Midway City Council  
18 June 2019  
Work Meeting

Whitaker Farm Subdivision /  
Final Approval

## CITY COUNCIL MEETING STAFF REPORT

**Subject: Whitaker Farm Subdivision –Final Plan Review**

ROUNABOUT ENLARGEMENT

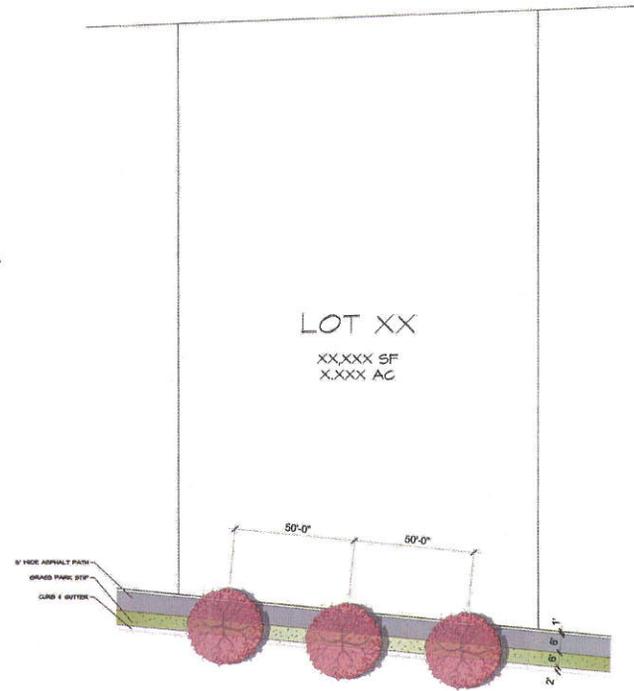
- The existing plans show a round-a-bout at the Memorial Hill entrance. The proposed round-a-bout will provide access to Memorial Hill and 15 parking spaces for the pedestrian access to Memorial Hill.
